Re: Source Materials License SUA-1534
Docket No. 40-8943
Mine Unit 1 Restoration; Response to Request For Additional Information

**Crow Butte Resources, Inc.
Response to U.S. Nuclear Regulatory Commission
Request For Additional Information**

Mine Unit 1 Groundwater Restoration Completion

Crow Butte Uranium Project

Mine Unit 1 Molybdenum Trend

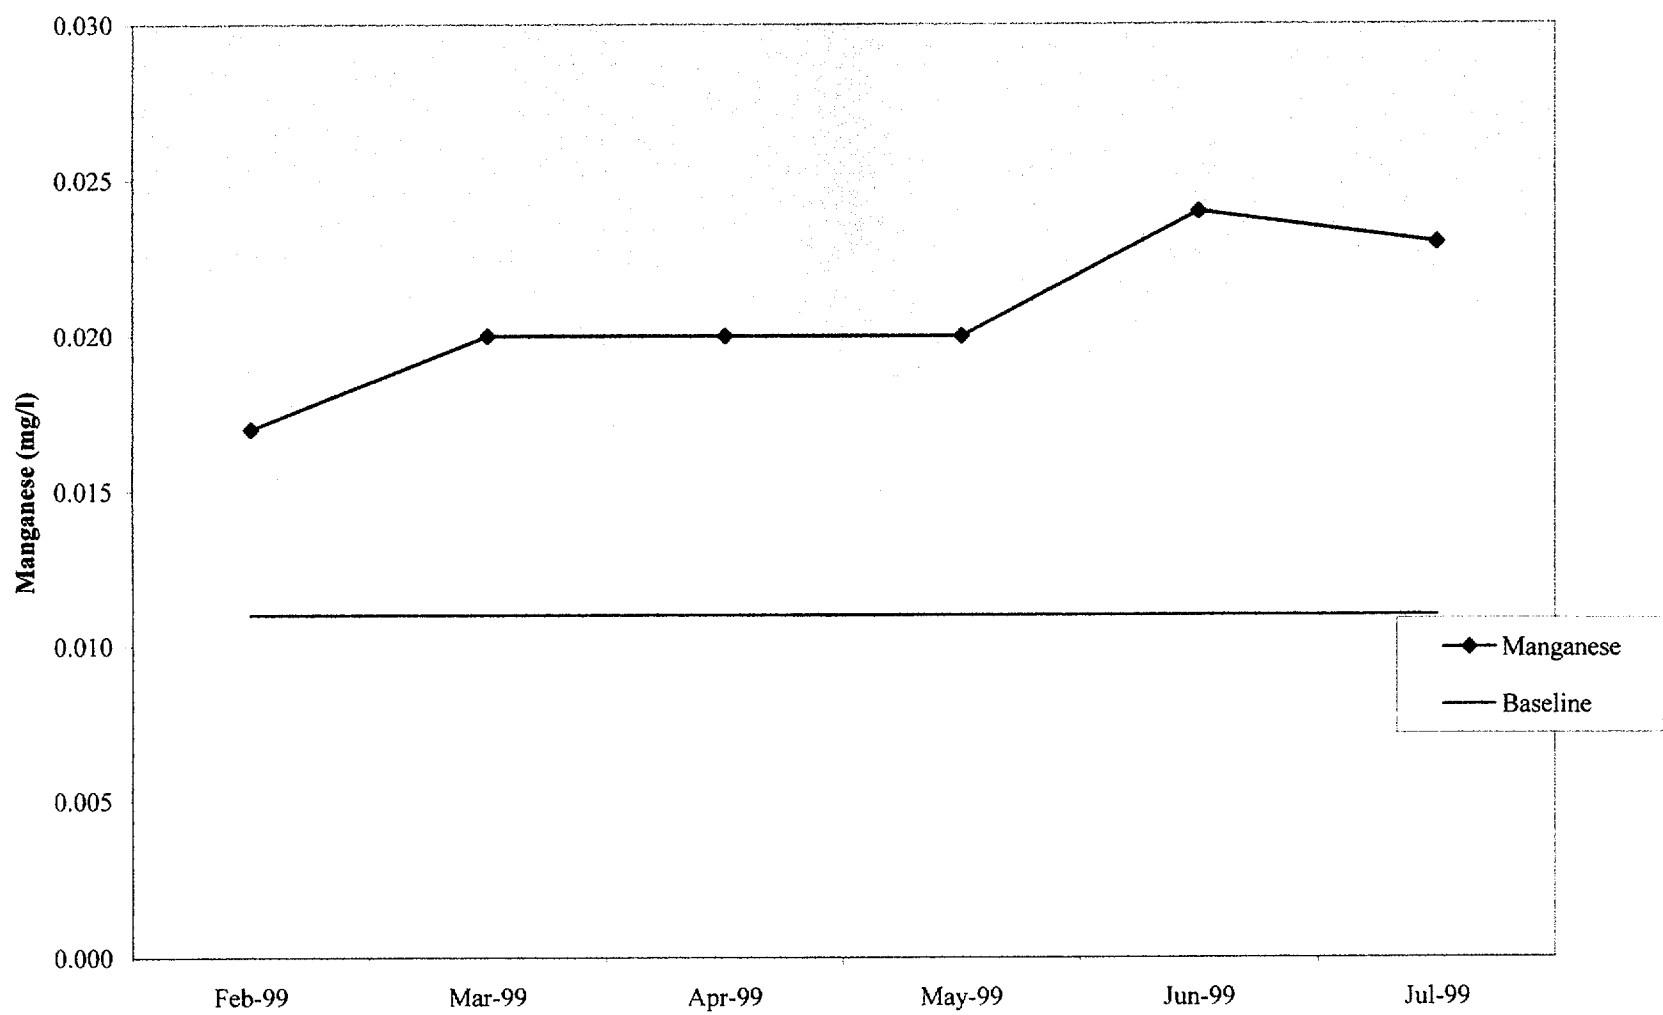
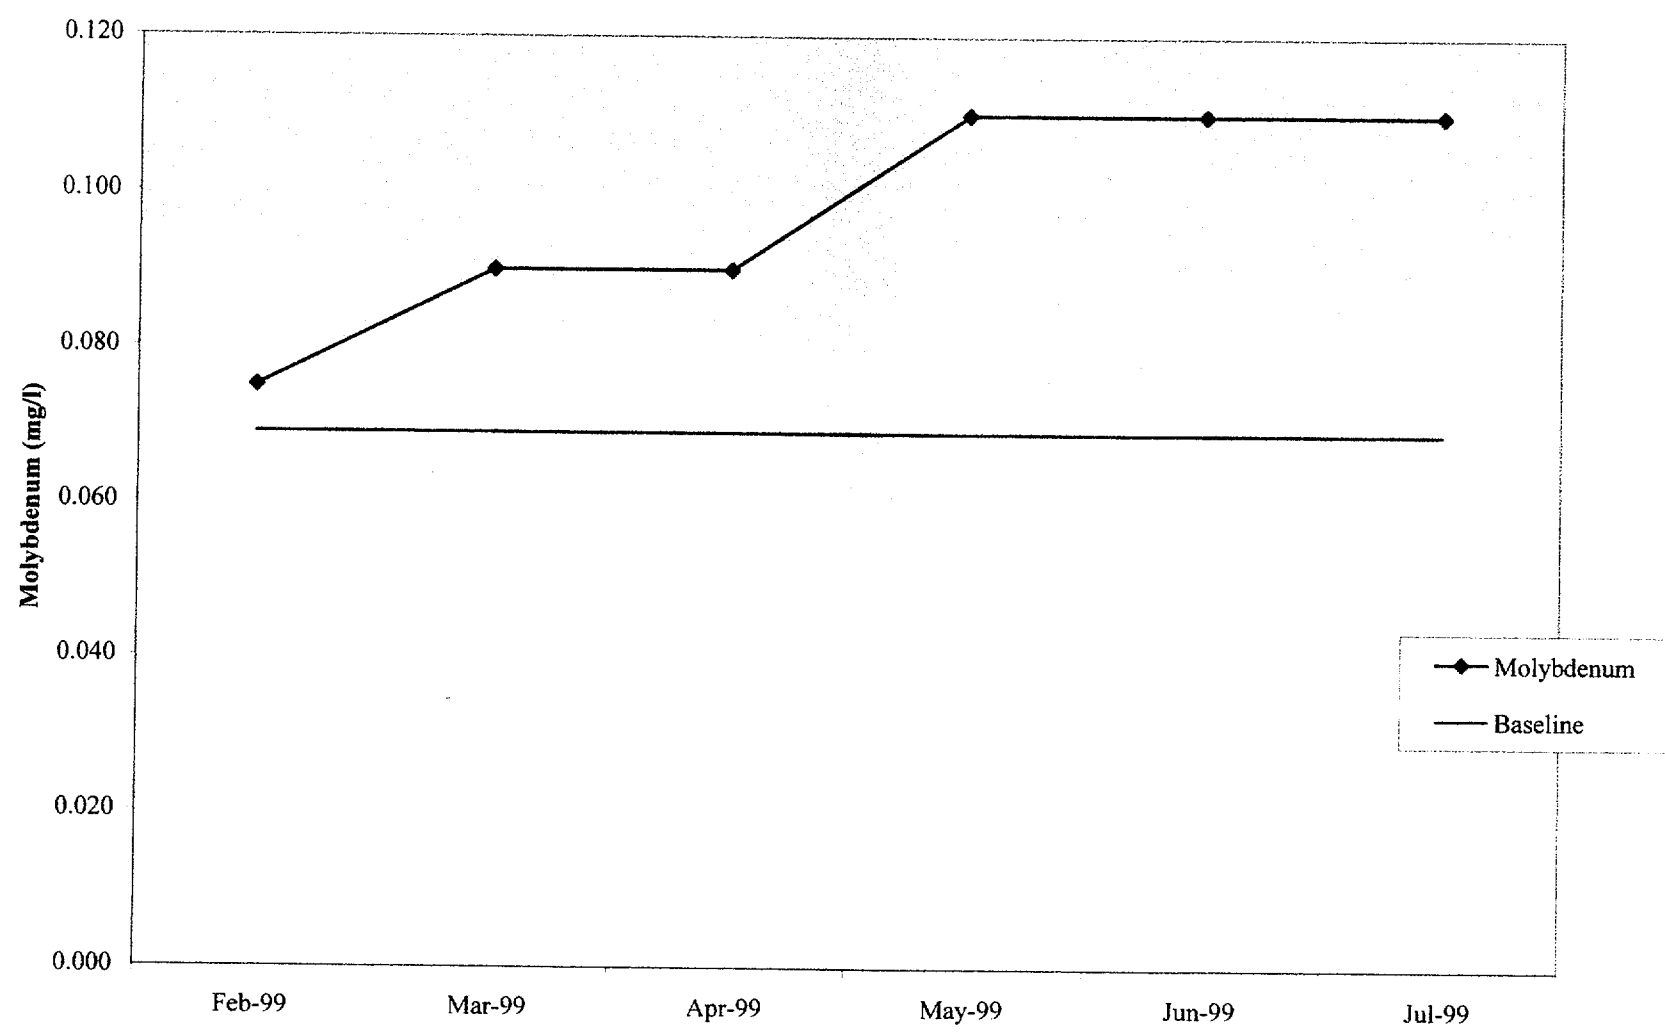
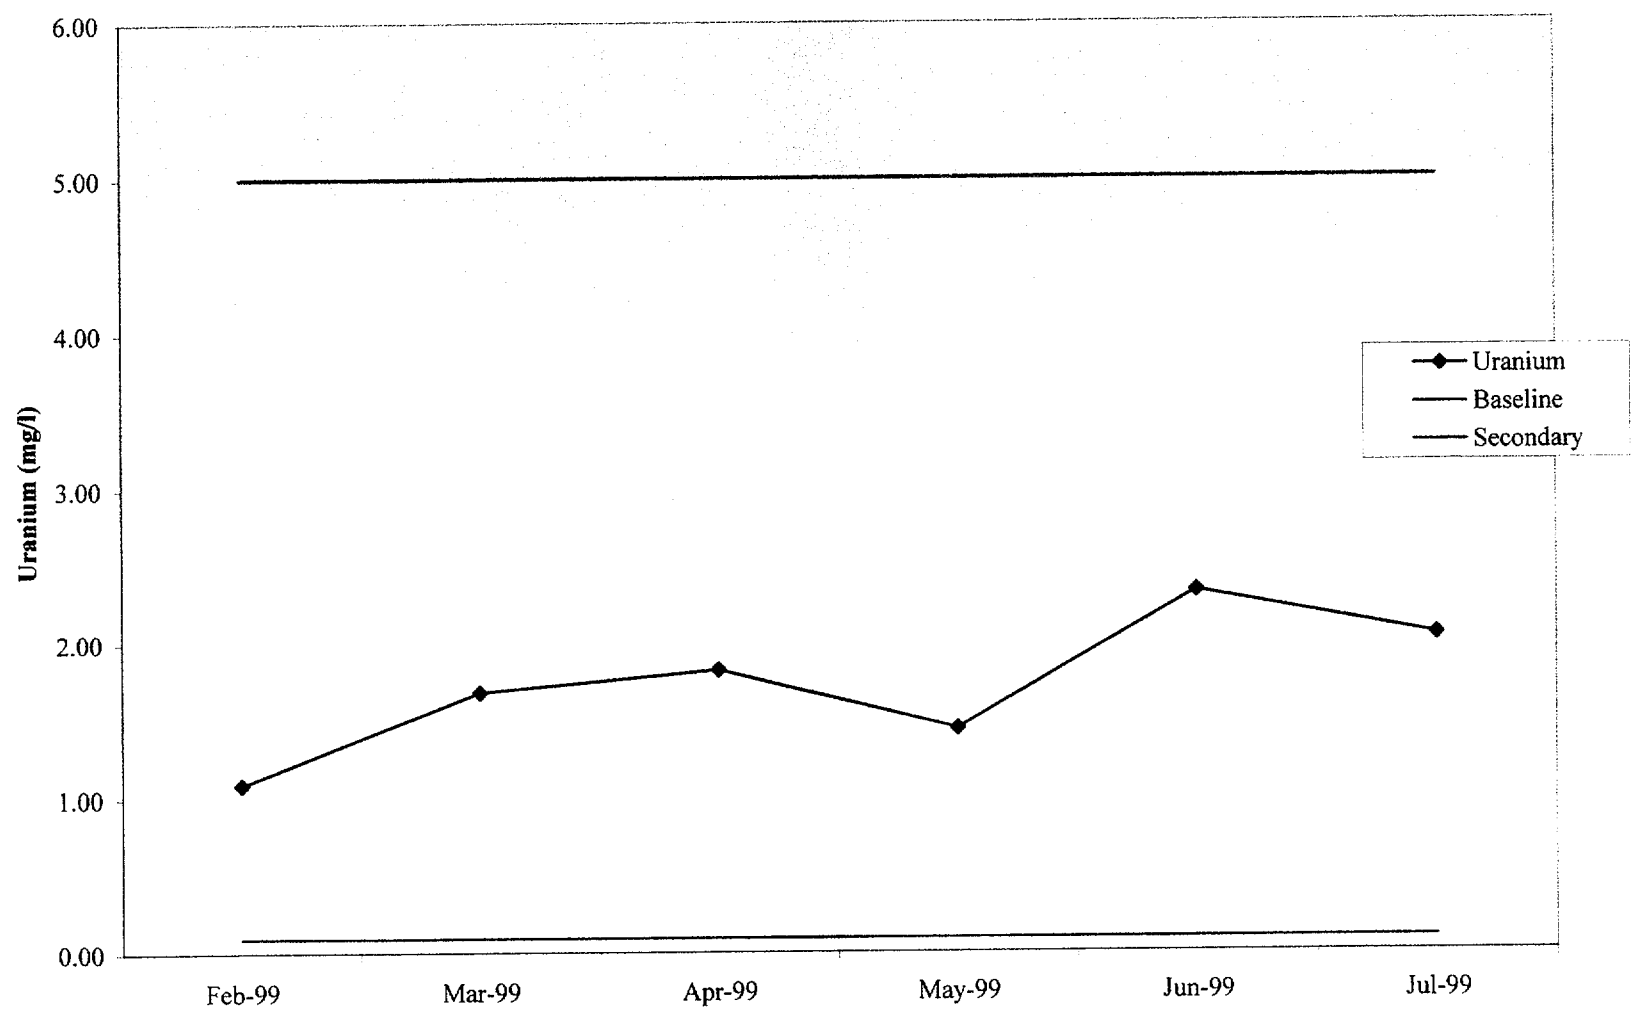
The NRC noted "strongly increasing" trends in a number of restoration parameters during the six month stabilization period. Specifically, NRC noted increasing trends in uranium, carbonate, potassium, radium-226, calcium, ammonium, chloride, iron, magnesium, manganese, molybdenum, sodium, sulfate, and total dissolved solids. In NRC's opinion, these trends could indicate that Mine Unit 1 was not stable during the stabilization monitoring period. NRC requested the following information to support CBR's position that Mine Unit 1 is stable.

Appendix A contains trend graphs from the stabilization period for all fourteen parameters identified by NRC. The graphs include a reference line for the average baseline concentration of the parameter. A review of these graphs indicates that most parameters do not exhibit a significant increasing trend, particularly when the final sample results are considered. Of the fourteen parameters listed by NRC, eleven showed no change or a significant decrease in the final stabilization sample. Only three parameters (ammonia, iron and magnesium) exhibited an increasing trend throughout the stabilization period.

- Ammonia was restored to concentrations below baseline. The final sample was 0.18 mg/l, or approximately 50 percent of the baseline concentration of 0.37 mg/l. It should be expected that ammonia concentrations would increase until natural background concentrations are restored.

- Iron exhibits a strong trend throughout the stabilization period, increasing from 0.049 to 0.127 mg/l. However, restoration successfully reduced iron to concentrations well below the secondary restoration goal. The final sample was 0.127 mg/l, or 42 percent of the restoration standard of 0.30 mg/l, which is based on the EPA Secondary Drinking Water Regulations (SDWR).
- Magnesium increased from 4.3 to 6.1 mg/l during the stabilization period. However, restoration successfully reduced magnesium to concentrations well below the secondary restoration goal. The final sample was 6.1 mg/l, or 19 percent of the restoration standard of 32 mg/l. Note that there are no EPA or NDEQ numerical standards for magnesium. The restoration standard is based upon one order of magnitude above baseline concentrations due to the ability of some major ions to vary with pH.
